Access Compliance Report

Public Rights-of-Way

Intersection ID: 2507	Main Street: CAMBRIDGE_BAY_DR	Cross Street: SNOW_HILL_CT	Location: NE
ADA ID: 2354CF106A86	Ramp Type: Perp	Initial Pass/Fail: Pass	Overall Compliance: No
Severity Score: 20.25			
Codes/Mitigation Info/Possible Solution		Field Measurements/Component Compliance

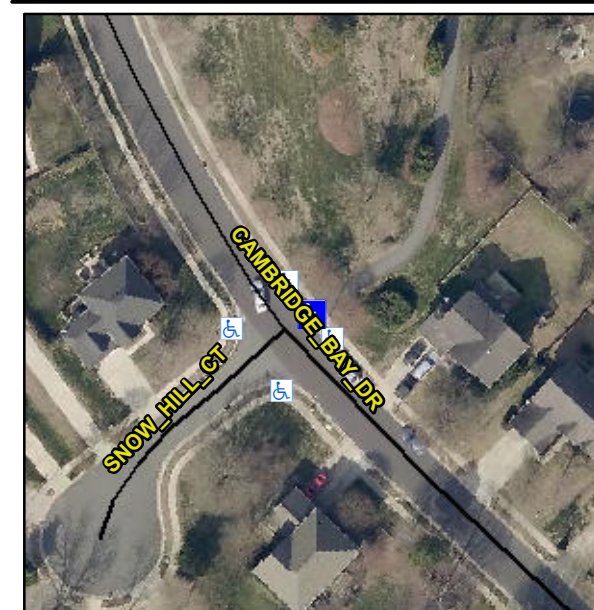
**Not Found, R304.5.3, R304.2.1,
R304.2.2-Perp, R304.3.2-Para,
R304.2.3, R305, R302.7.2**

Compliance	Description	Data	Compliance	Description	Data
N/A	Ramp Length (in)	47.0	Yes	Ramp Slope (%)	7.6
Yes	Ramp Width (in)	48.0	No	Ramp XSlope (%)	4.8
N/A	Flare Type LT	Sloped	N/A	Flare Type RT	N/A
N/A	Flare Slope LT (%)	10.2	Yes	Flare Slope RT (%)	1.0
N/A	Flare Traversable LT?	Yes	N/A	Flare Traversable RT?	Yes
No	Landing Length (in)	47.0	No	DWS Provided?	No
Yes	Landing Width (in)	48.0	N/A	DWS Contrast?	No
No	Landing Slope (%)	5.6	N/A	DWS Length (in)	N/A
Yes	Landing X Slope (%)	3.4	N/A	DWS Full Width?	No
N/A	Landing Curb? (Y/N)	No	N/A	DWS Offset (in)	N/A
N/A	Shared Landing?	No			
Yes	Gutter Ponding?	No	Yes	Gutter Slope (%)	0.2
No	Gutter Lip Ht (in)	0.5	No	Gutter X Slope (%)	5.0
N/A	Painted X Walk1?	No	N/A	Painted X Walk2?	N/A
	X Walk 1 Direction	To SW		X Walk 2 Direction	N/A
N/A	X Walk 1 Width (in)	N/A	N/A	X Walk 2 Width (in)	N/A
	X Walk 1 Slope (%)	4.8		X Walk 2 Slope (%)	N/A
	X Walk 1 X Slope (%)	4.7		X Walk 2 X Slope (%)	N/A

**Remove & Replace Entire Ramp.
Remove & Replace Gutter.**
